## Accessibility Design Review Report

St. Michael's Uniting Church  
120 Collins Street  
Melbourne, Victoria

Dated: 09 December 2024

Reference: EG-241208-AC

DRAWING NO.  
**AX-100**

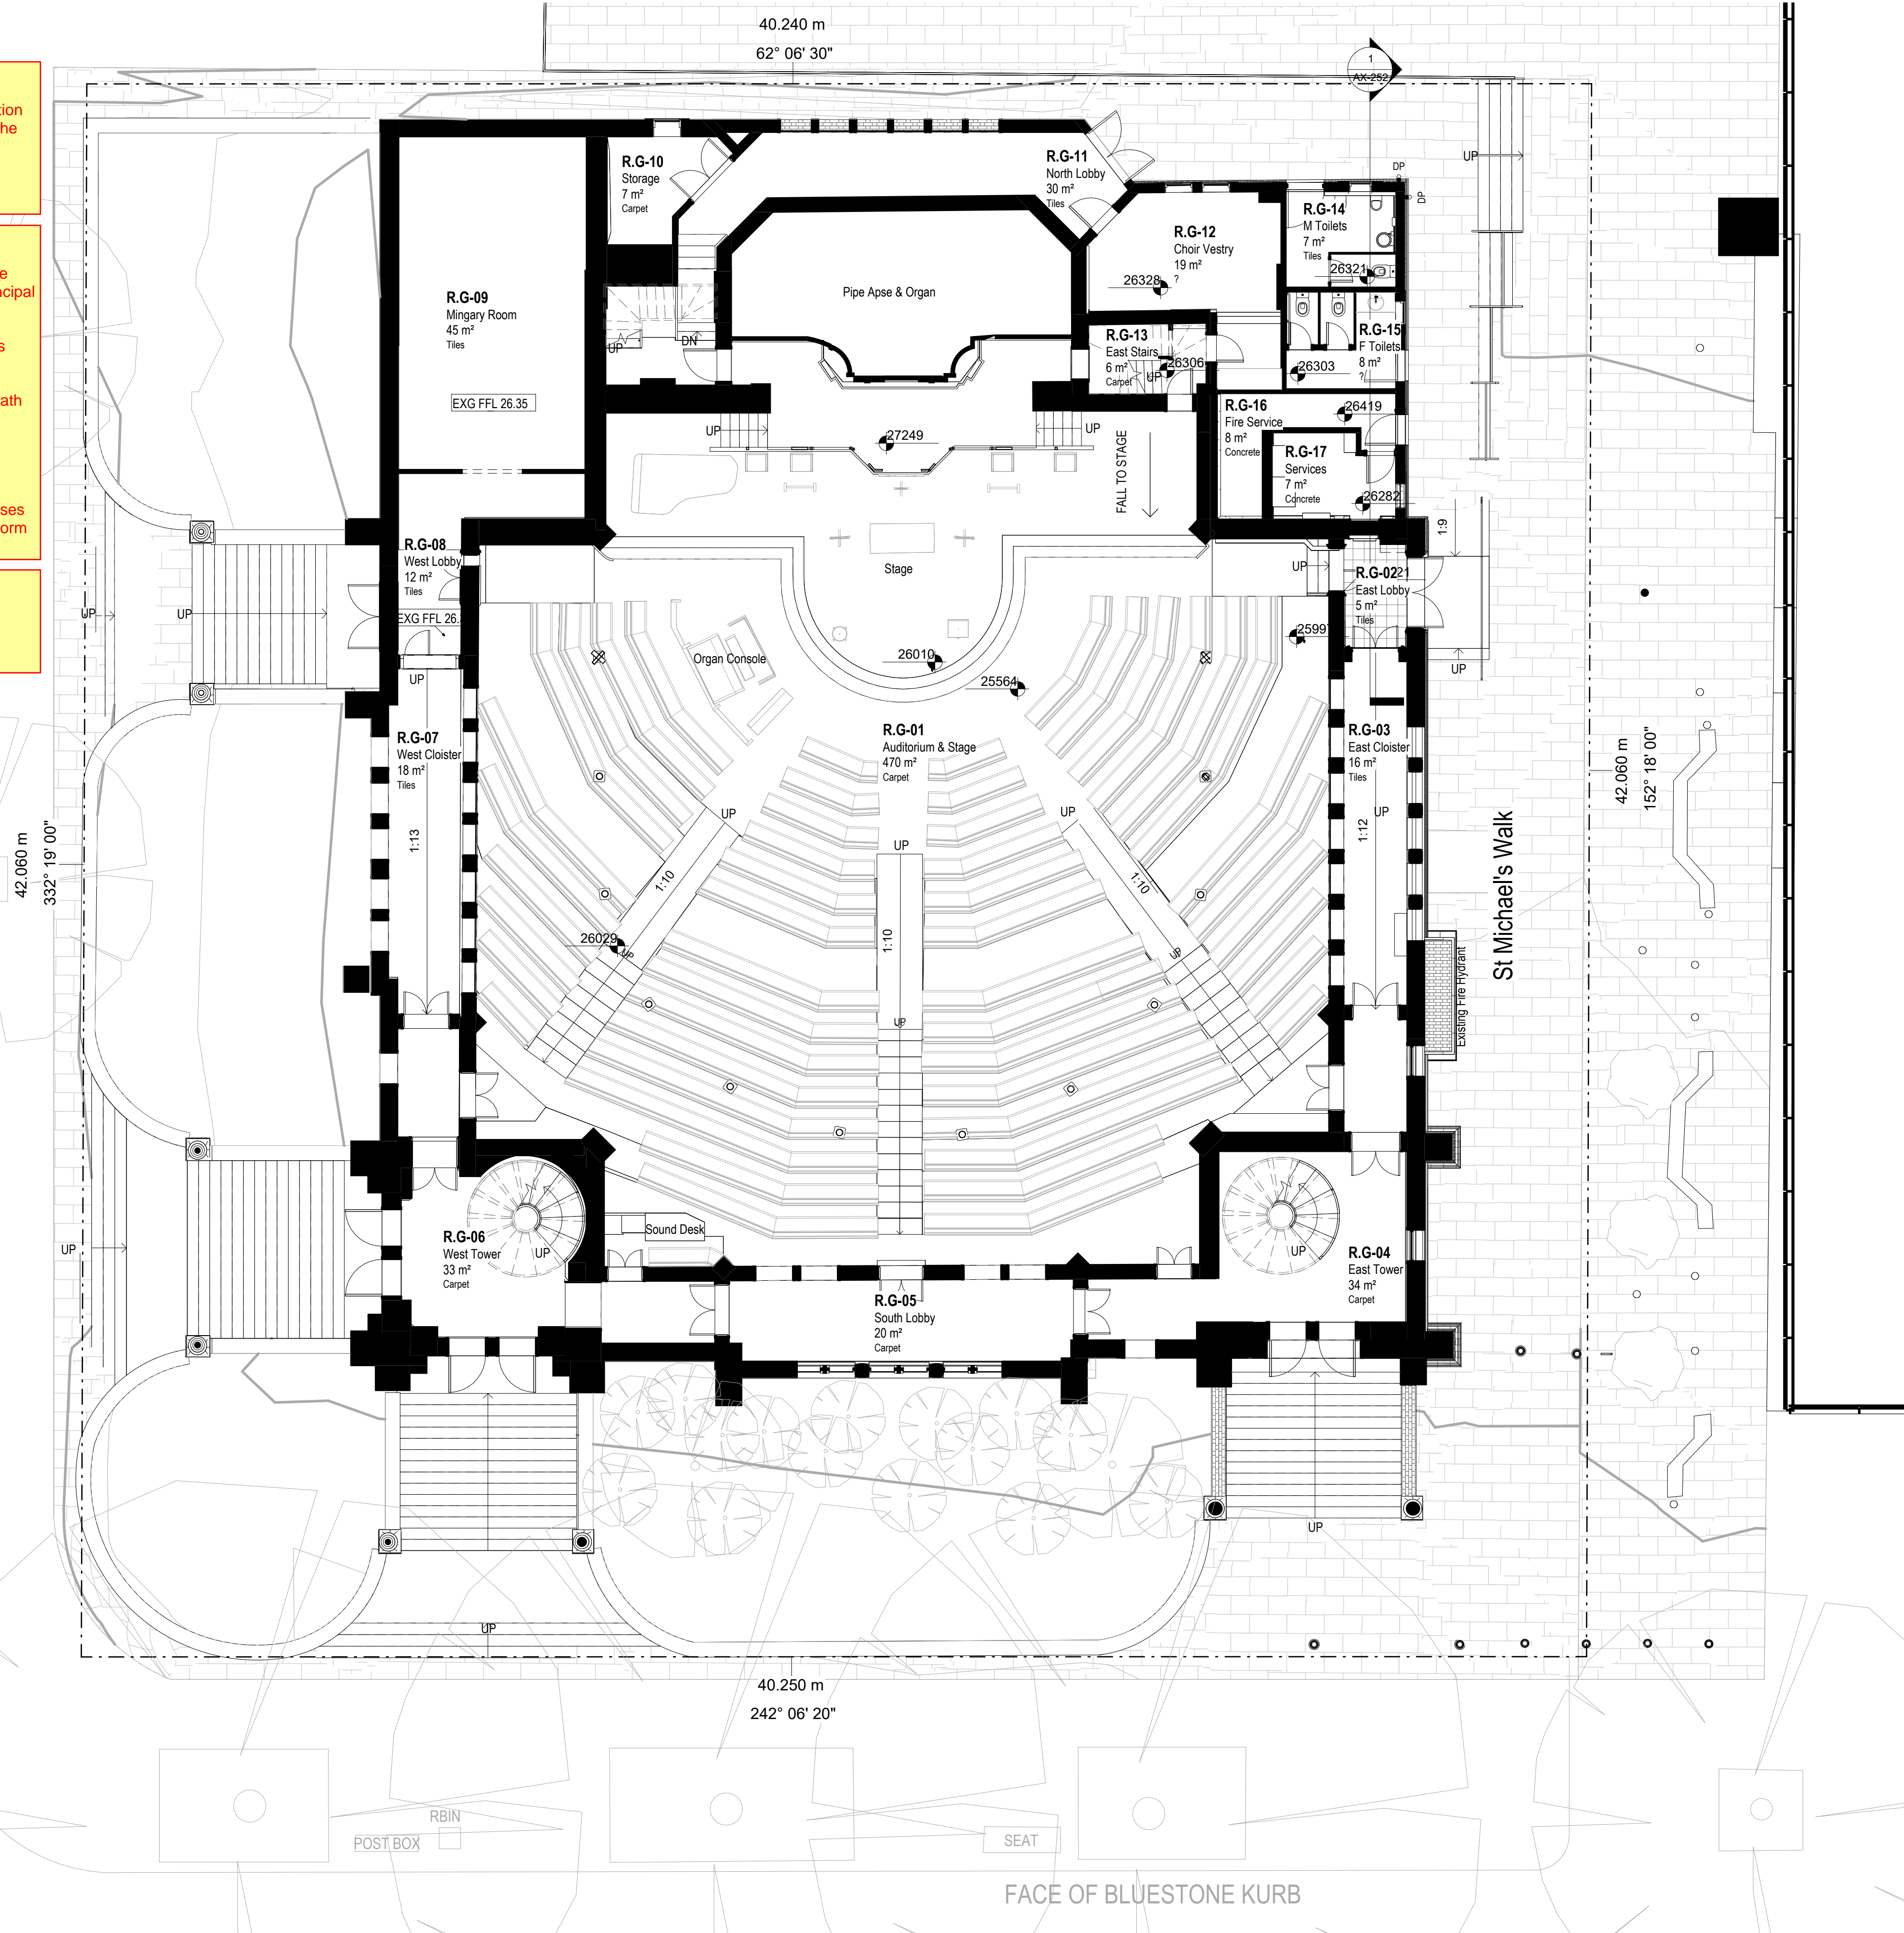
While the principal pedestrian entrance of a building is not defined in the BCA or Premises Standards, we believe it extends to any external stairways and ramps that structurally form part of the entrance arrangements.

DRAWING TITLE  
 Proposed Ground Floor Plan

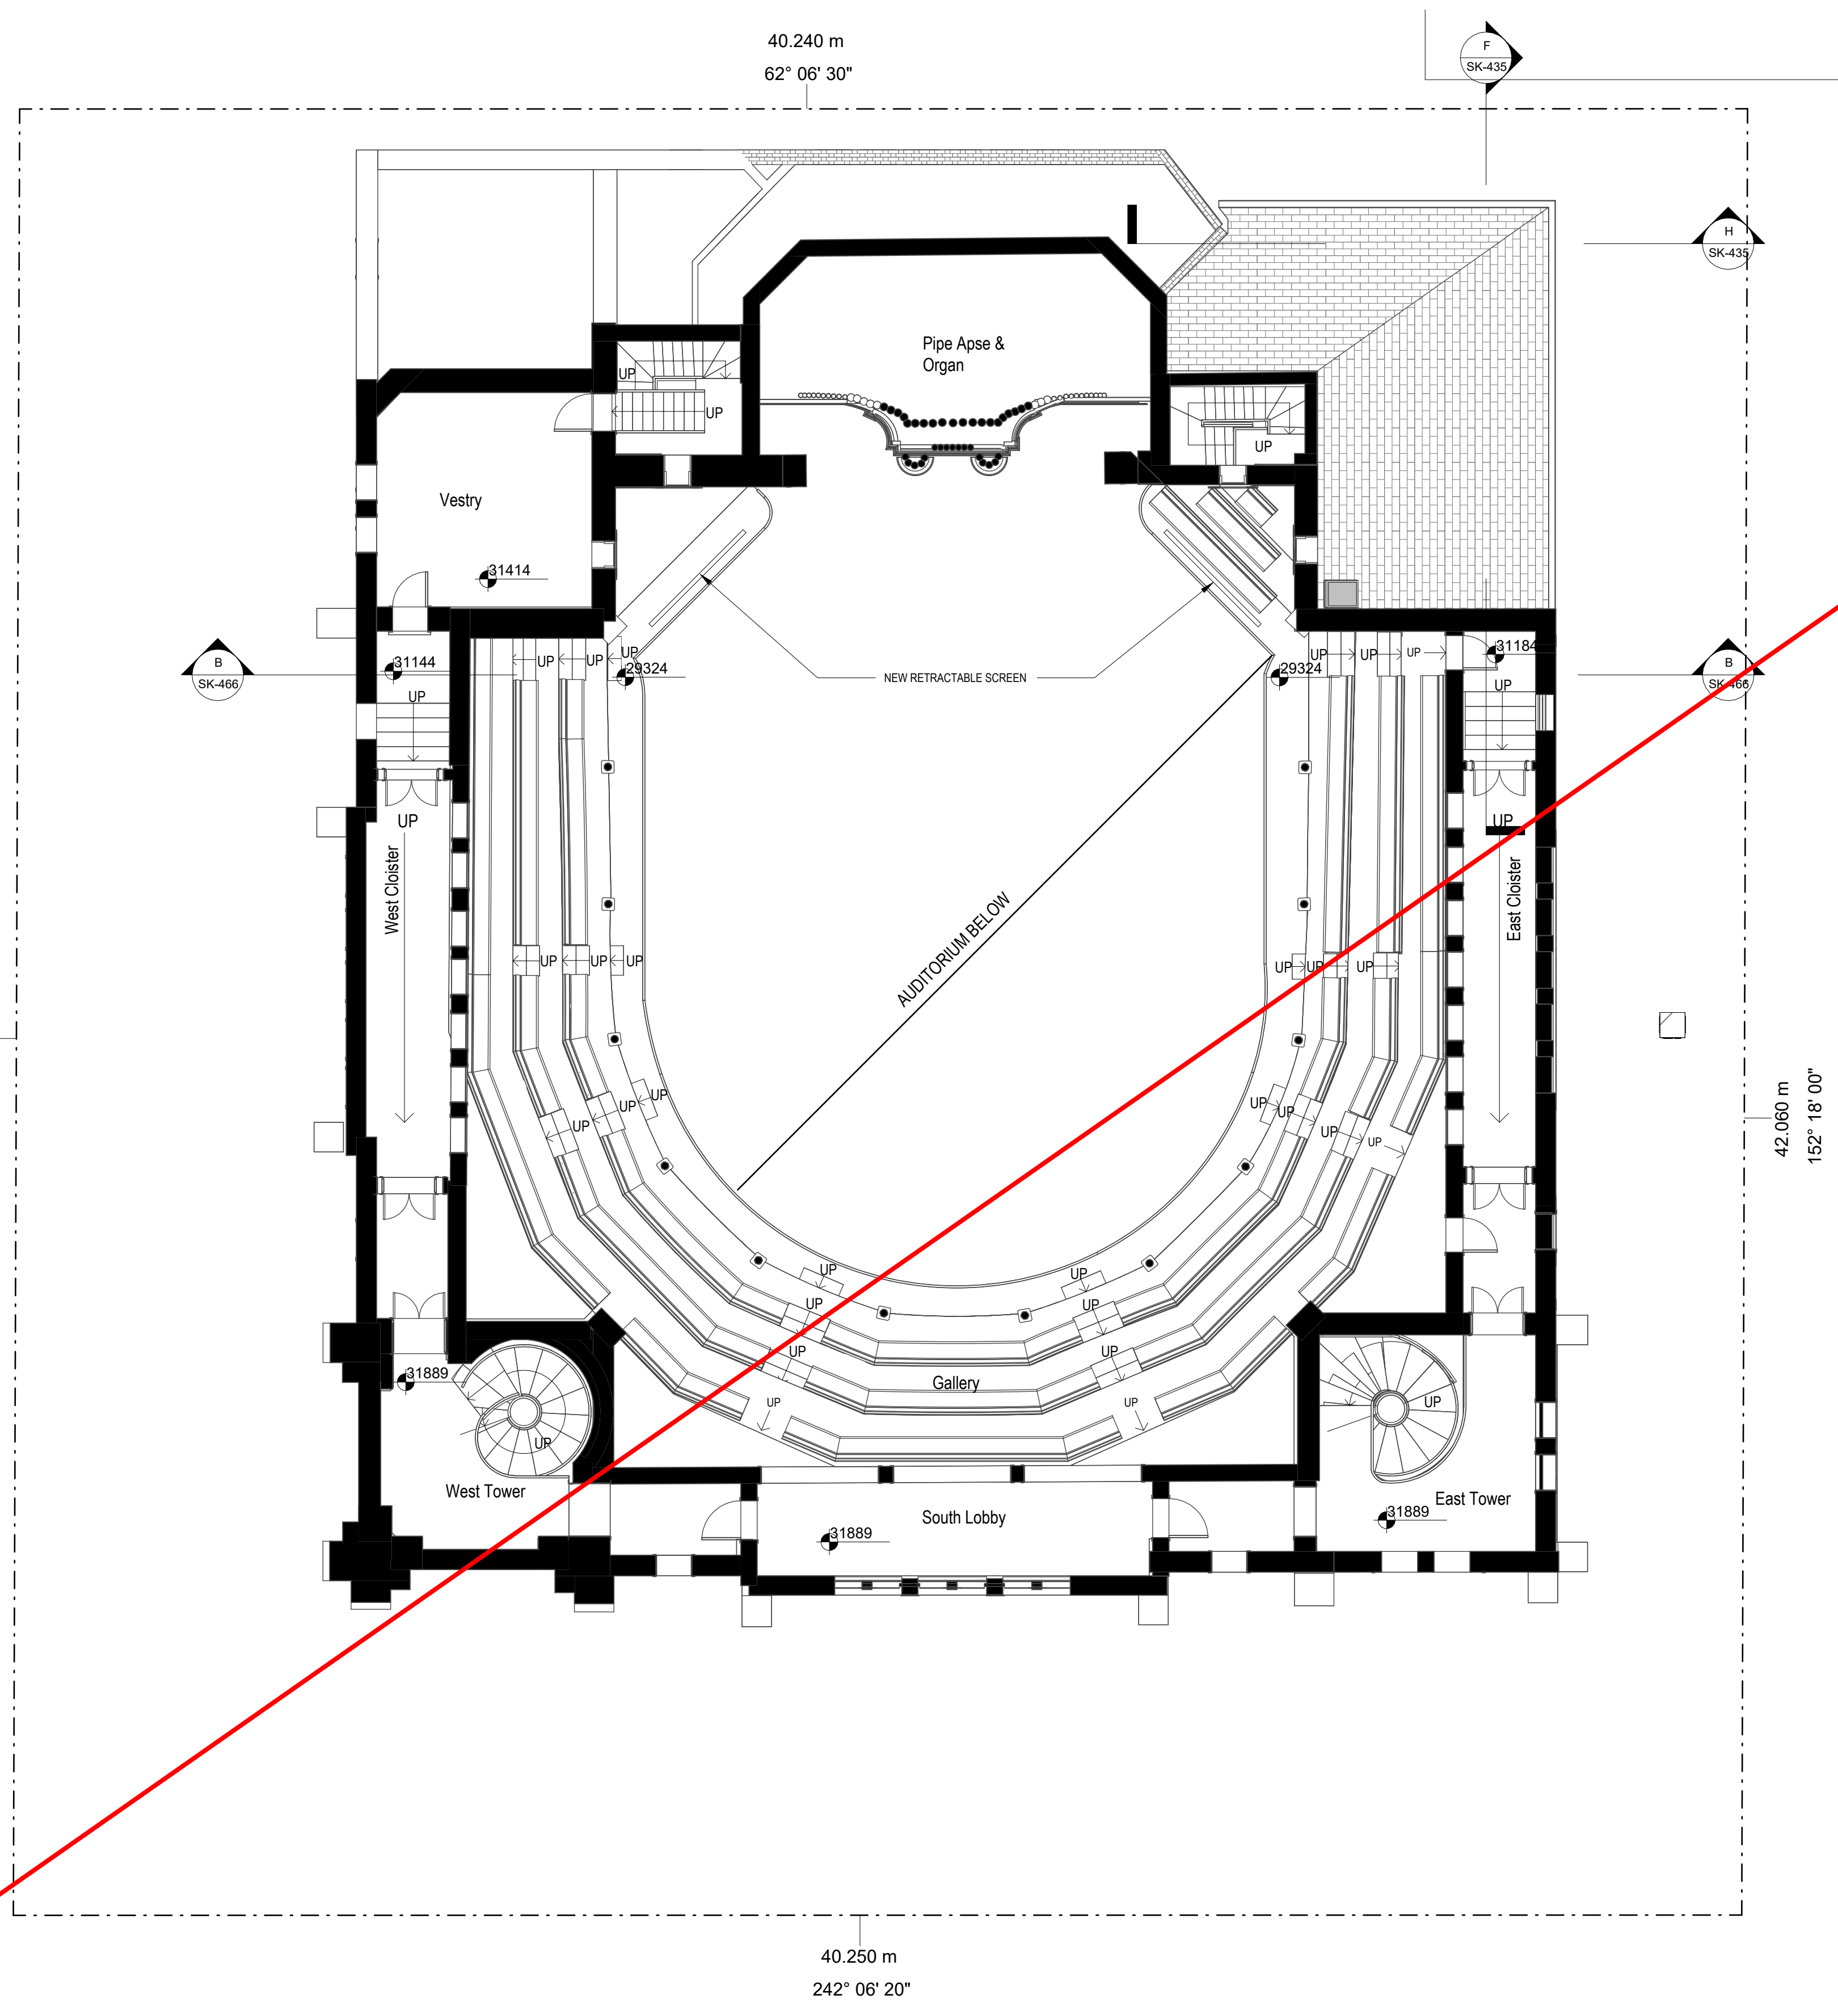
Consider a form of visual warning/identification along the edge of the stage (i.e. LED strip lighting or a stair tread contrasting nosing strip).

Wayfinding signage should be provided at the bottom of each stairway on Collins Street to direct people to the accessible entrance to St. Michael's Walk.

Additional signage should be provided at the St. Michael's Walk entrance to assist with wayfinding.

1 Demolition Floor Plan  
Demolition Entry Upgrade Plan  
1:50 @ A1

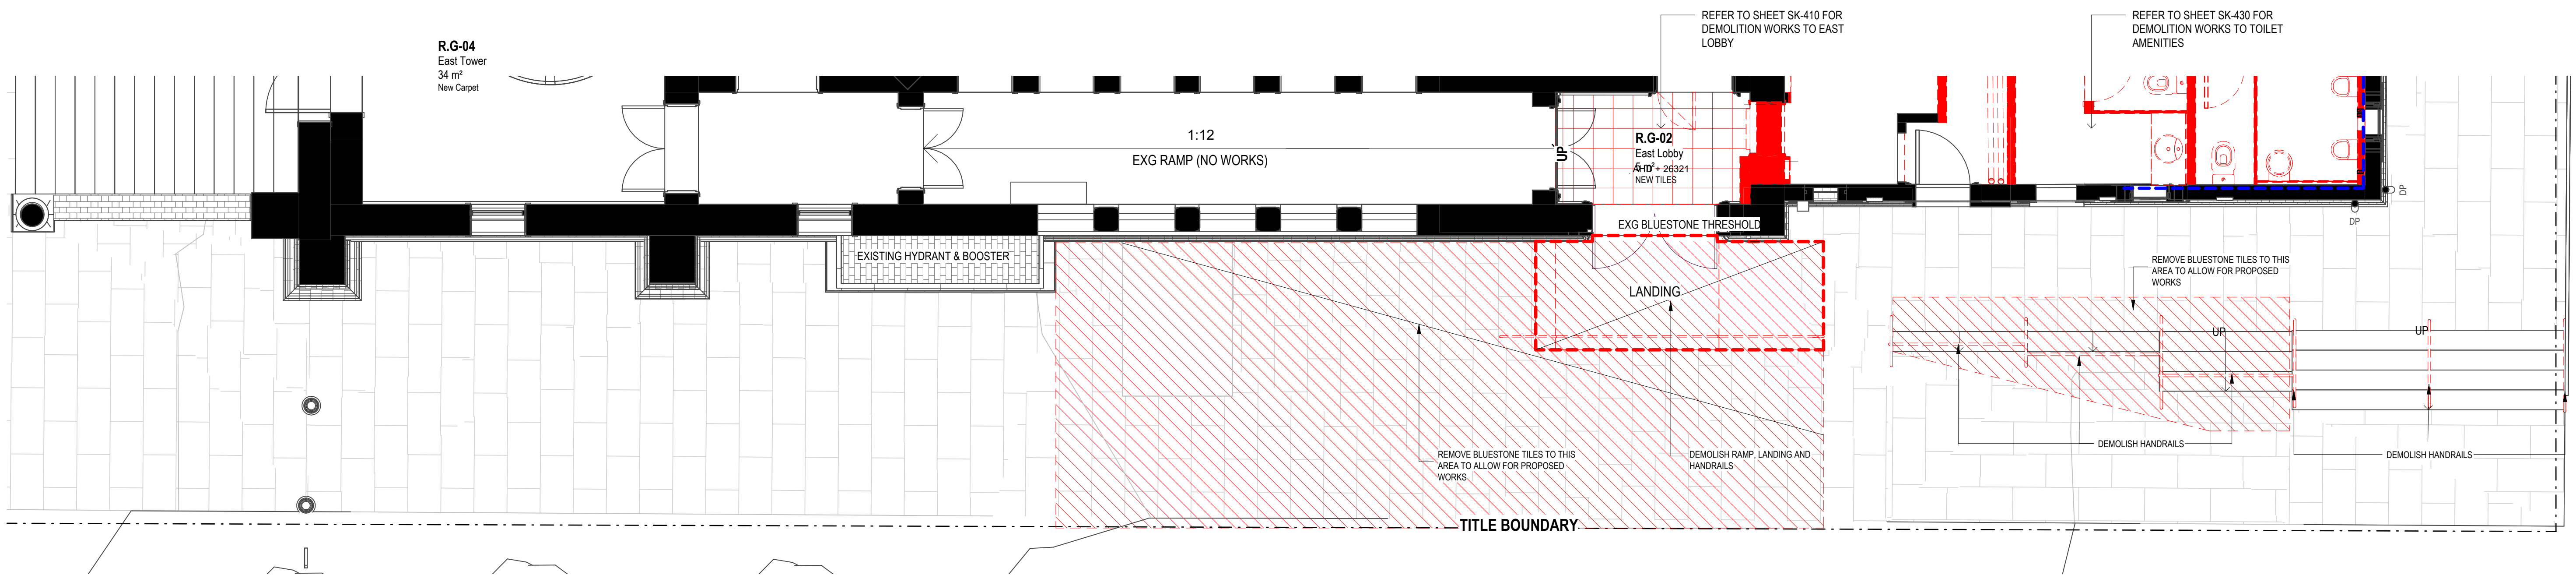
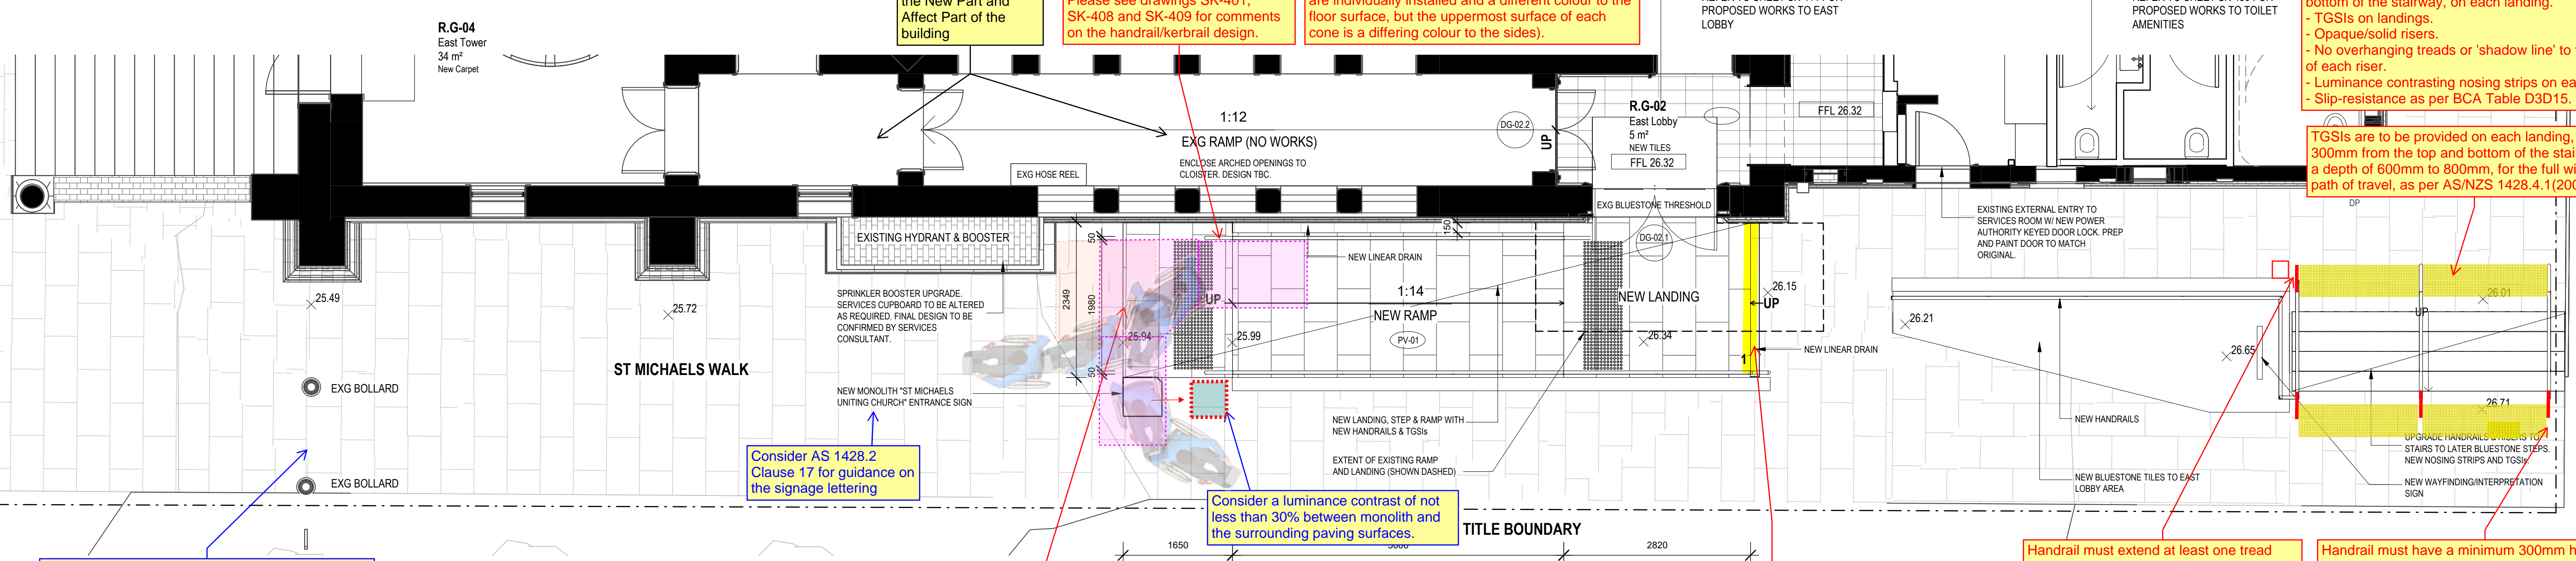
- A minimum 1000mm unobstructed width between handrails.
- Handrails on both sides.
- Appropriate handrail extensions on the top and bottom of the stairway, on each landing.
- TGSIs on landings.
- Opaque/solid risers.
- No overhanging treads or 'shadow line' to the face of each riser.
- Luminance contrasting nosing strips on each tread.
- Slip-resistance as per BCA Table D3D15.

TGSIs are to be provided on each landing, setback 300mm from the top and bottom of the stairway, for a depth of 600mm to 800mm, for the full width of the path of travel, as per AS/NZS 1428.4.1(2009).

Consider a luminance contrast of not less than 30% between bollards and the surrounding floor surfaces.
